MXD
CAMBRIDGE, MA

INFILL DEVELOPMENT CONCEPT PLAN

AMENDMENT 2
RESPONSE TO COMMENTS

NOV 5 2021
SASAKI

R.ES FIG. 1

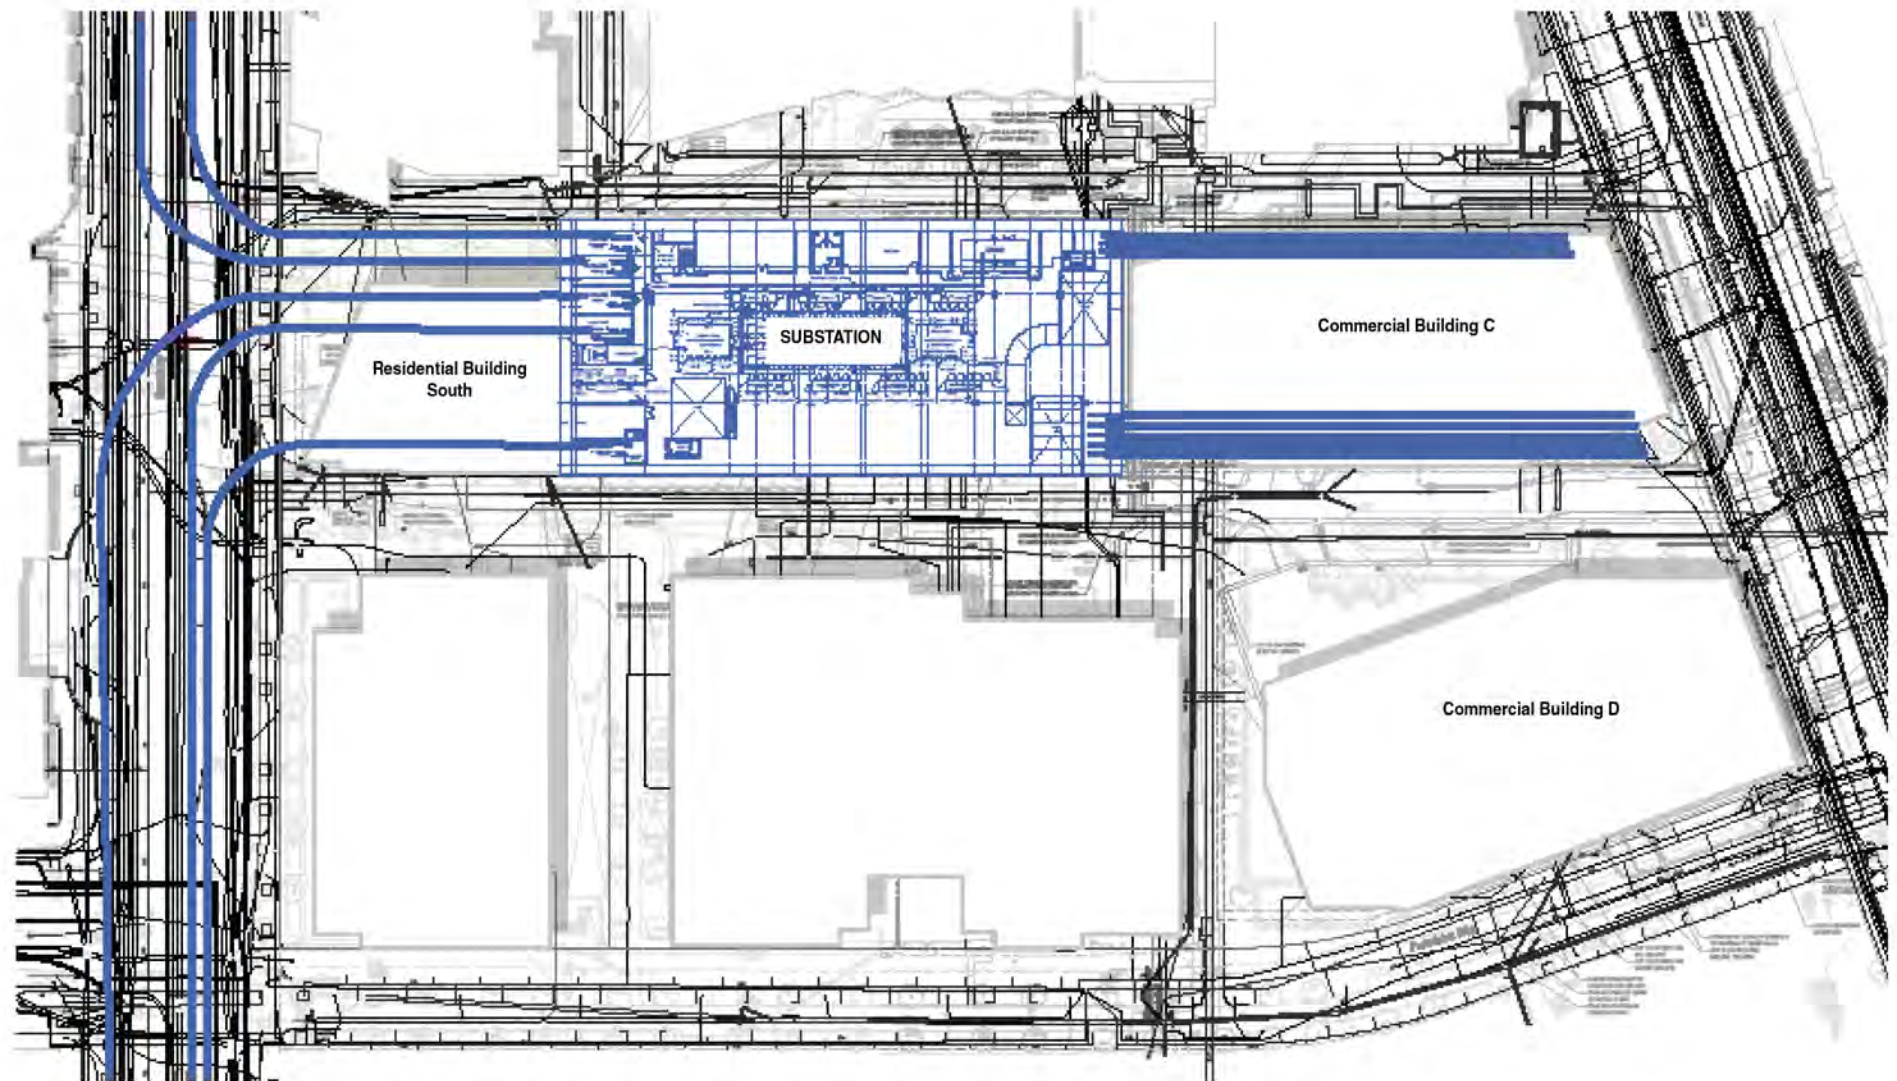
Comment Reference: CRA Staff Letter

The proposed electrical substation vault is planned to occupy a footprint of approximately 285' x 100' x 110' in the approximate center of the current Blue Garage parcel. As presented at the Joint Board hearing on 9/28/21 and discussed during the re-zoning process, this central positioning of the electrical substation is driven primarily by transmission and distribution considerations. The transmission and distribution duct banks pivotal for the proposed substation's operational viability are subject to critical engineering requirements including maximum bend radius constraints, limitations on depth, and minimizing proximity to underground heat sources that degrade electrical capacity. When the extremely crowded subsurface conditions beneath Broadway, Binney, and the Blue Garage service drives are overlaid on the foregoing requirements, the enormous scale of the routing challenge becomes clear.

To date, the interconnected proposed siting for the substation, transmission, and distribution duct banks within Concept Plan Amendment #2 represents the only viable known proposal for effectuating the substation relocation to the MXD. By extension, this configuration of proposed substation infrastructure elements determines the program distribution opportunities available to the Applicant within Concept Plan Amendment #2. Structural elements and subsurface spaces of the proposed commercial and residential buildings must be coordinated with the transmission and distribution duct banks exiting the substation, while the footprint of the substation itself cannot be overbuilt, but can function as public open space.

R.ES FIG. 2

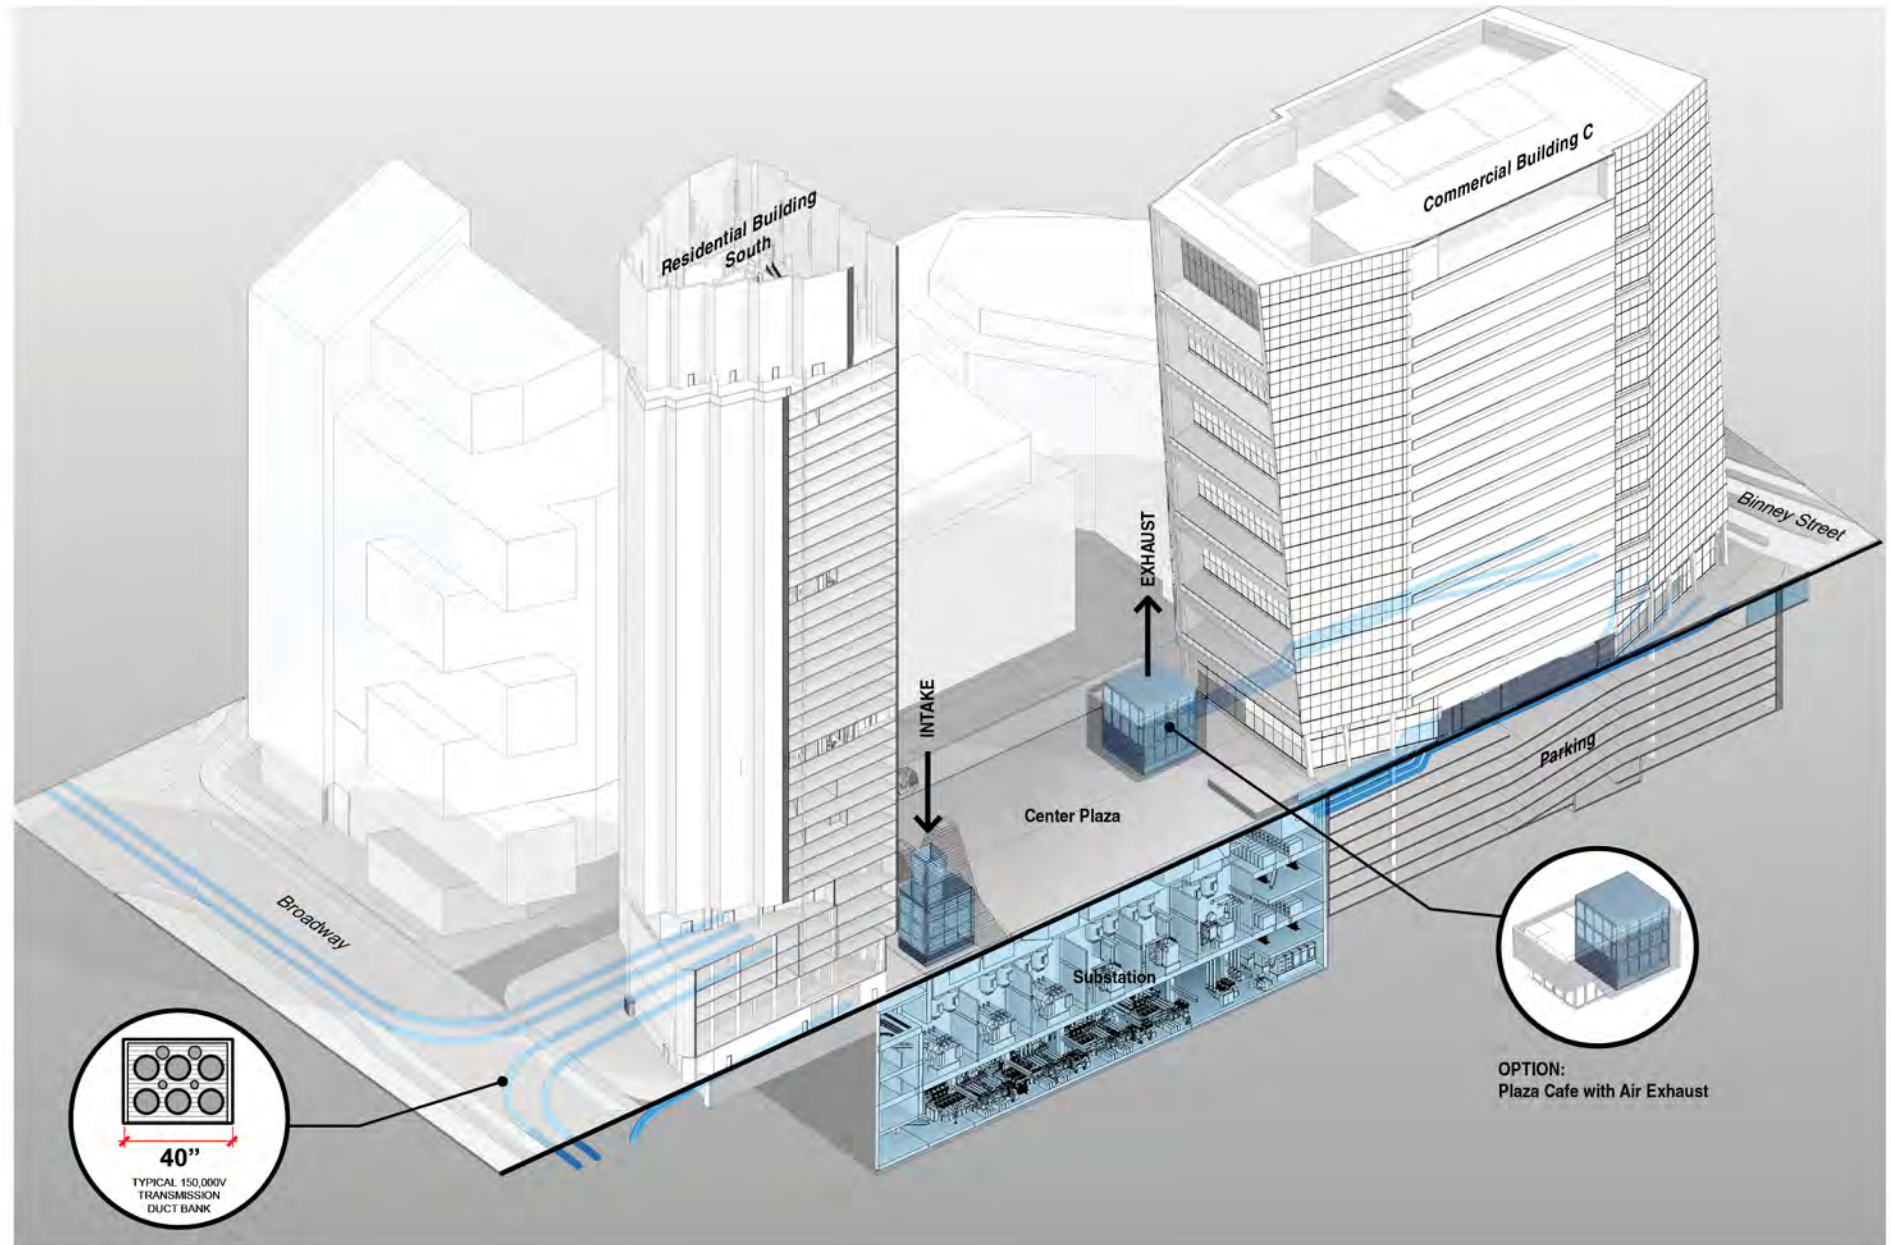
Comment Reference: CRA Staff Letter

While precise details of the interior of the proposed electrical substation must be withheld on account of security concerns, the same logic of space constraints and interdependent engineering decisions applies within the substation vault. The interior of the proposed below grade electrical substation is anticipated to be filled with carefully selected and sited equipment responsive to both the internal needs of the substation's machinery and the positioning of vertical shafts—including ventilation, equipment hatchways, loading elevators, and stairways—that run through the entirety of the substation and ultimately reach its roof. This relationship illuminates the close connection between the nature of the Center Plaza and internal substation engineering requirements and why decisions about the configuration of the Plaza must ultimately be made relative to electrical substation design considerations.

R.1.1 FIG 1

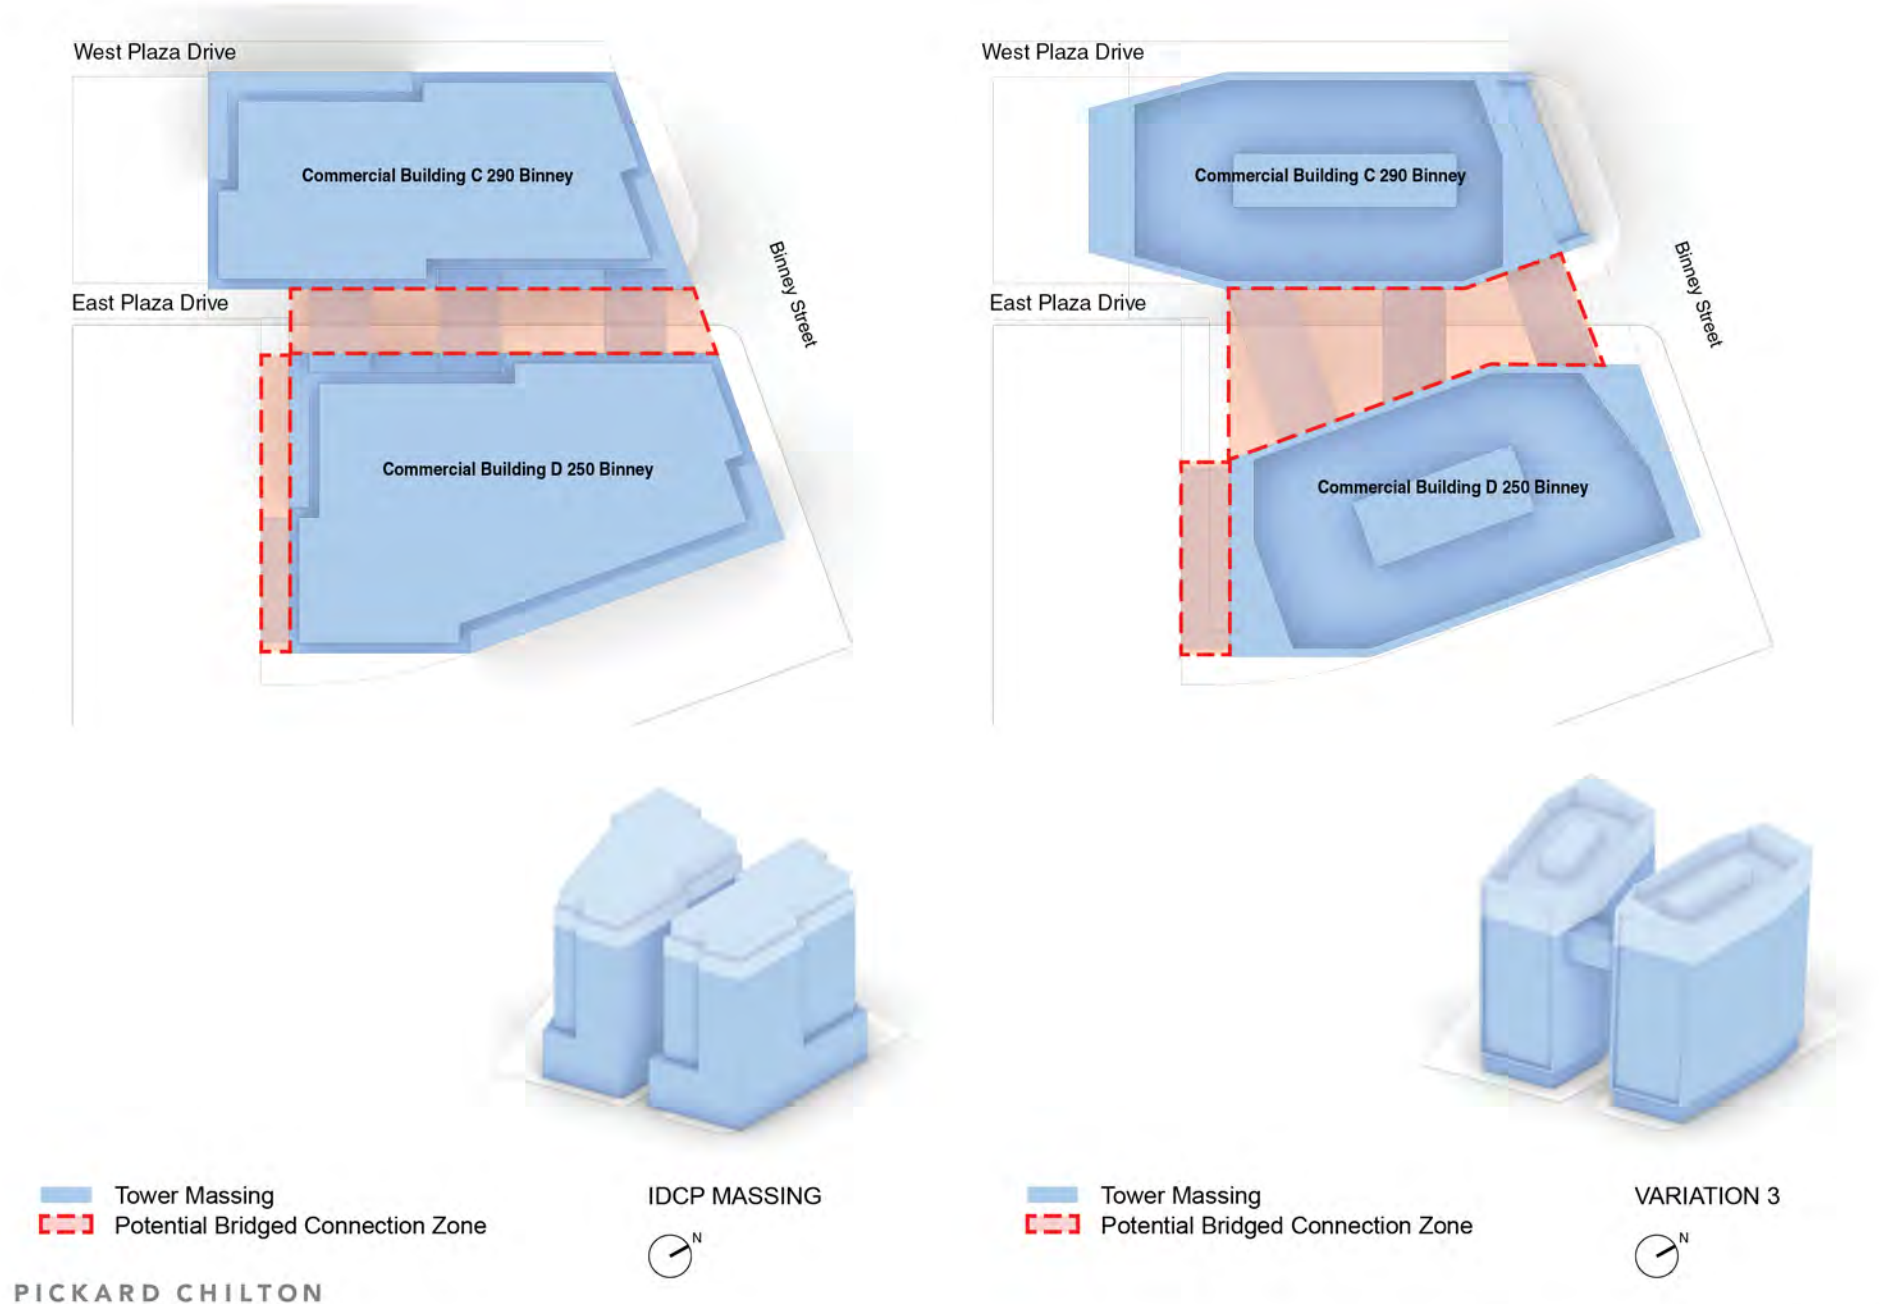
Comment Reference: CRA Staff Letter, CDD Staff Letter

The Applicant received several comments and questions about the massing and the relationship between Commercial Building C and D and the Center Plaza. A discussion of massing concepts for Commercial Buildings C and D must begin with a reckoning of the binding site and programmatic constraints operating at the north end of the proposed redevelopment area. As has been recounted in earlier sections of this response to comments document, the incorporation of extensive substation infrastructure effectively dictates where commercial and residential buildings can be positioned. With transmission and distribution engineering considerations requiring a central positioning of the substation, space for residential and commercial development can consequently only be found to the south and north of the substation itself. This general site constraint is given still further definition when retention of the existing east and west service drives and enhancement of the existing East-West connectors is brought to the fore. This further restricts the footprints for residential and commercial development to the sites depicted consistently in our public meetings and IDCP submissions. Finally, limits on building height mandated by the Cambridge Zoning Ordinance provide the final building envelope constraint that the Applicant intends to work within. Refer to R.1.1 FIG. 1 - FIG. 4 for a visual summary of how these various constraints cumulatively shape the building envelope available for Commercial Building C and Commercial Building D.

Bearing in mind how these constraints shape the building envelope, the next key factor driving the baseline massing concepts for Commercial C and Commercial D is the amount of commercial program that must be distributed between these two available sites. The economic viability of the proposed substation relocation and development plan represented in Concept Plan Amendment #2 depends explicitly on deploying the 800,000 SF of commercial Utility Project GFA contemplated in the recently enacted changes to Article 14 of the Zoning Ordinance (the "MXD Zoning") and Amendment No. 11 to the KSURP approved by the CRA Board on September 16, 2020, and by the Cambridge City Council on February 3, 2021. Without the ability to deliver a net increase of 800,000 SF of Utility Project GFA, the economic cross-subsidies undergirding the needed heavy infrastructure investment become insufficient and render Concept Plan Amendment #2 impossible for the Applicant to complete.

With these major parameters established it is essential to subsequently engage with an important genre of commentary received during the 9/28/2021 Joint Board Hearing. Specifically, assessing the potential value of attempting to consolidate the proposed commercial program within a single building so as to create additional potential for open space within Concept Plan Amendment #2. Relative to market considerations, the notion of a consolidated building incorporating the reconstructed and additional commercial GFA contemplated by Concept Plan Amendment #2 is prohibitive. Delivering the envisioned square footage in one consolidated commercial building represents an unacceptable speculative business risk to the Applicant. Moreover, design considerations suggest a two-building approach to be more advantageous on a number of dimensions including; circulation within the site, access to light and air, creating more human scaled experience. The single building scale would also limit the occupants' access to light and air; a key feature in sustainable building design and human comfort. Based on the design constraints listed above, making a single building on the site would have a negative impact on the community, surrounding site, and building occupants and is therefore not feasible.

R.3.1 FIG. 1

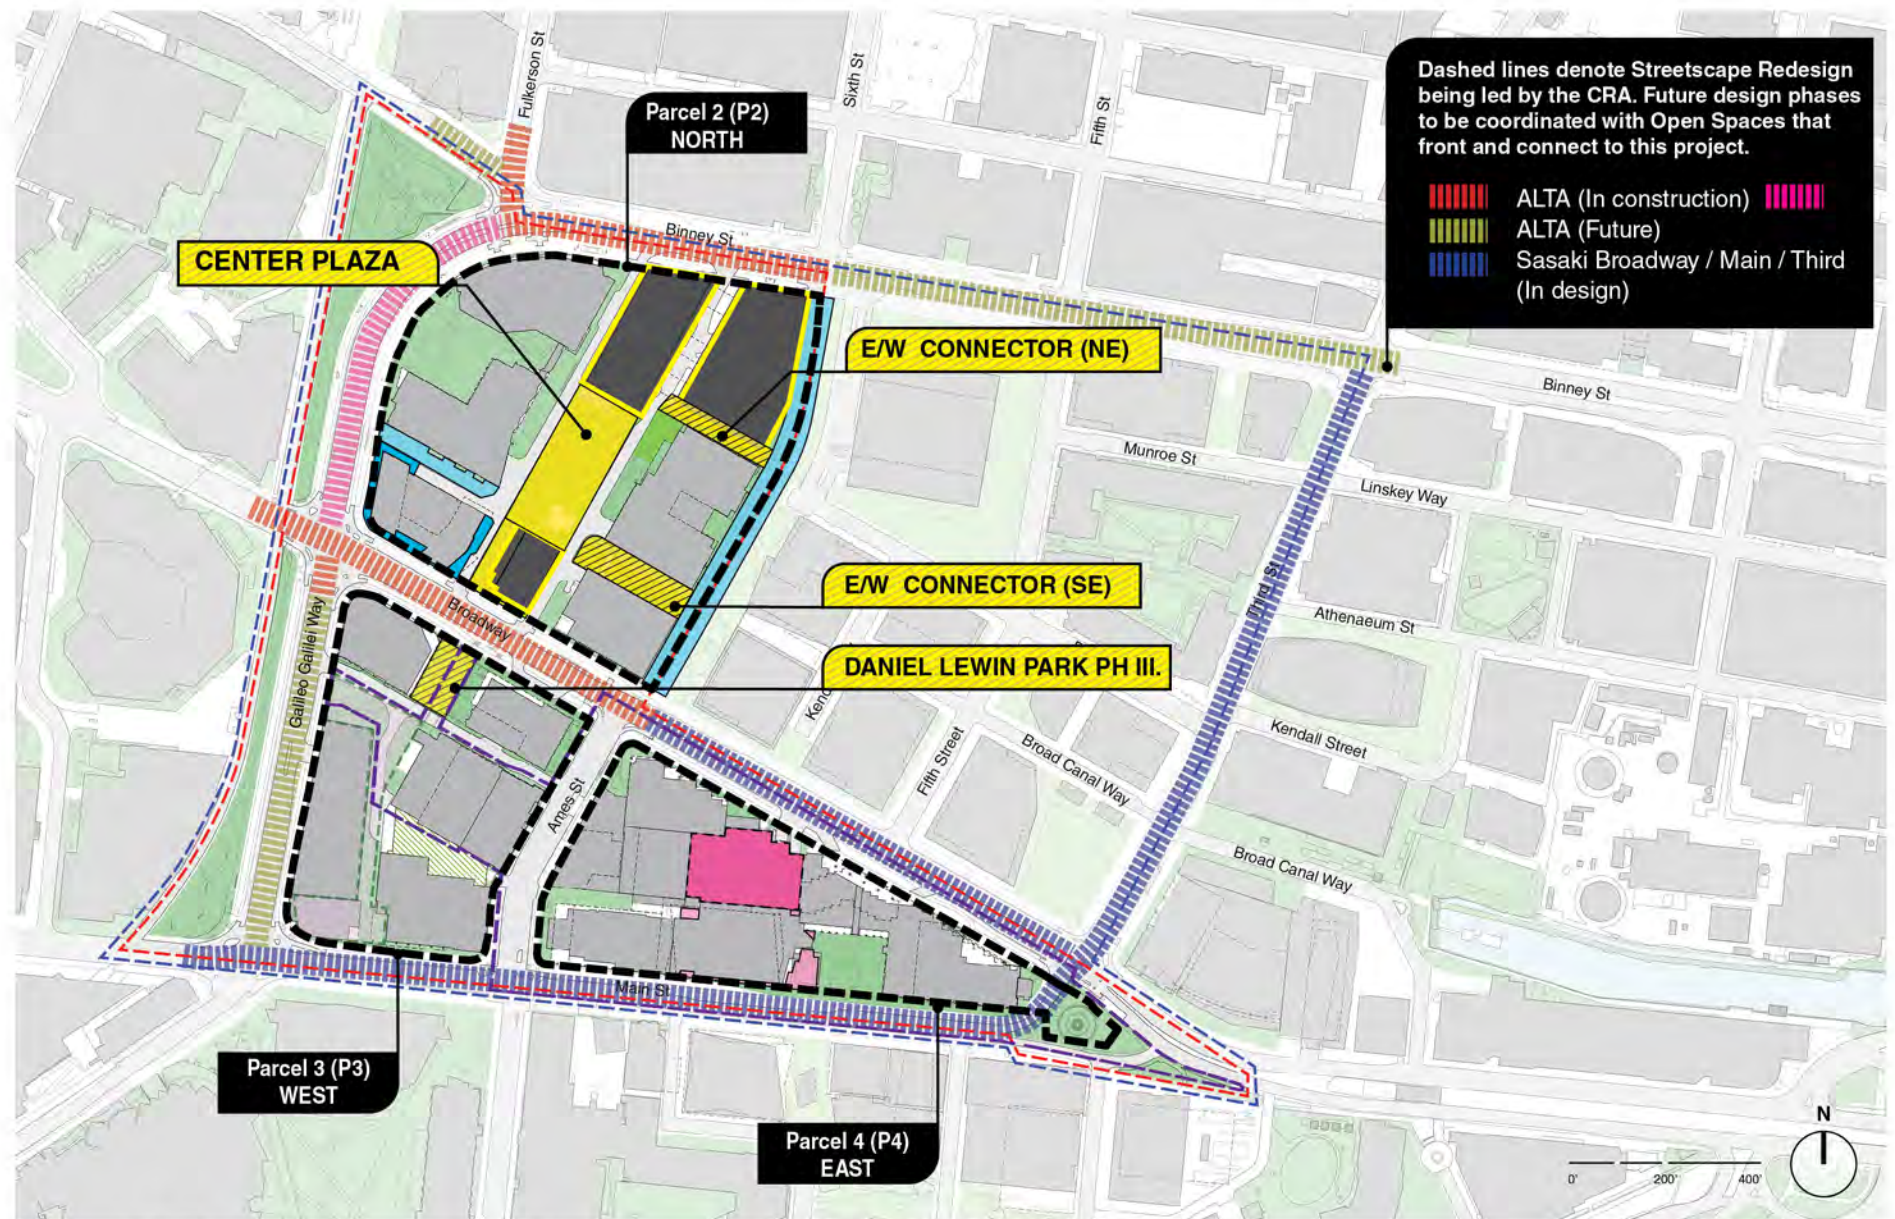
The Applicant received comments requesting additional information on open space proposed by the Project.

Setting aside the opportunity presented by the Fulkerson Street parcel, Concept Plan Amendment #2 contemplates a substantial net increase in open space on a standalone basis. Spurred by requests from community members, City Councilors and the Cambridge Redevelopment Authority (CRA), the Applicant worked diligently with Eversource to prove the feasibility of a below-grade substation within the proposed redevelopment during 2020. This below-grade substation made possible the approximately 30,000 SF Center Plaza public open space currently envisioned at the heart of Concept Plan Amendment #2. Taking this, as well as the East-West connectors and other open spaces created as part of this proposal, Concept Plan Amendment #2 is estimated to deliver a net increase of approximately 17,000 SF of open space within Parcel 2, compared to Concept Plan Amendment #1.
